Subject: **MHI's Response to US-APWR DCD RAI No. 921-6415 Revision 0 (SRP 06.02.02)**

Response to Request for Additional Information No. 921-6415
Revision 0

US-APWR Design Certification

RAI NO.:	**NO. 921-6415 REVISION 0**
SRP SECTION:	**06.02.02 – Containment Heat Removal System**
APPLICATION SECTION:	**6.2**
DATE OF RAI ISSUE:	**4/16 /2012**

Figure 1: Plan View in Reactor Cavity around Overflow Pipes

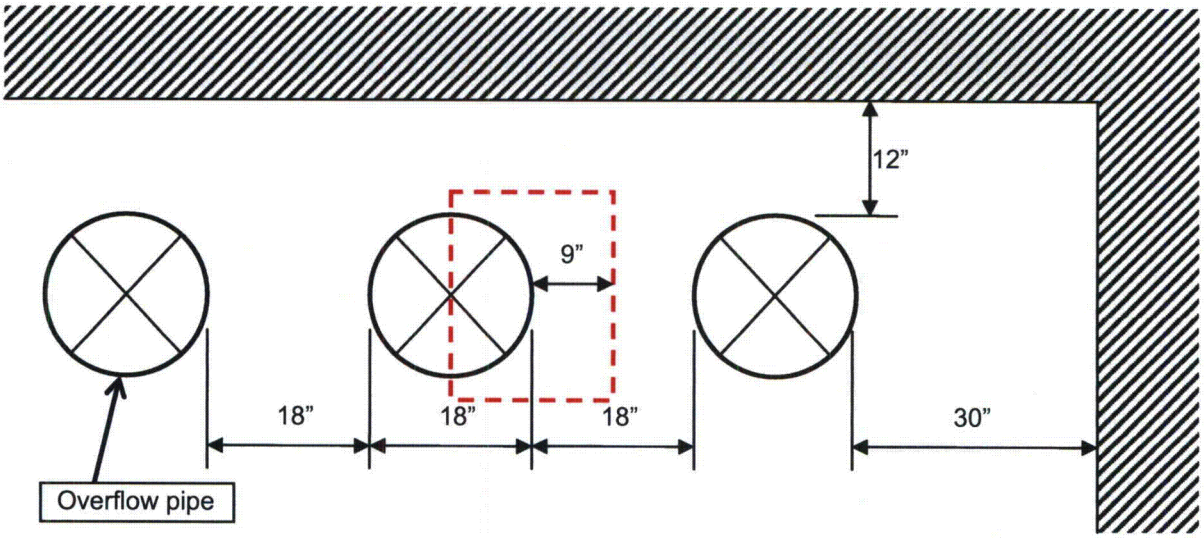
The water level (hold-up) analysis for each set (three total) of four overflow pipes did not address the arrangement of the overflow pipes and their proximity to each other (within a set) and structures. Therefore, it appears each pipe is treated as an individual pipe that is not influenced by neighboring pipes/structures. Provide an assessment of each set of four overflow pipes that justifies their treatment as individual pipes/circular weirs, taking into account their arrangement with each other and structures, or explain how this uncertainty is accounted for in the water hold-up analysis.

To evaluate the proximity effect, the red-dashed area in Figure 1 (the narrowest point) is conservatively modeled as shown in Figure 2. The following simplified assumptions were also applied:
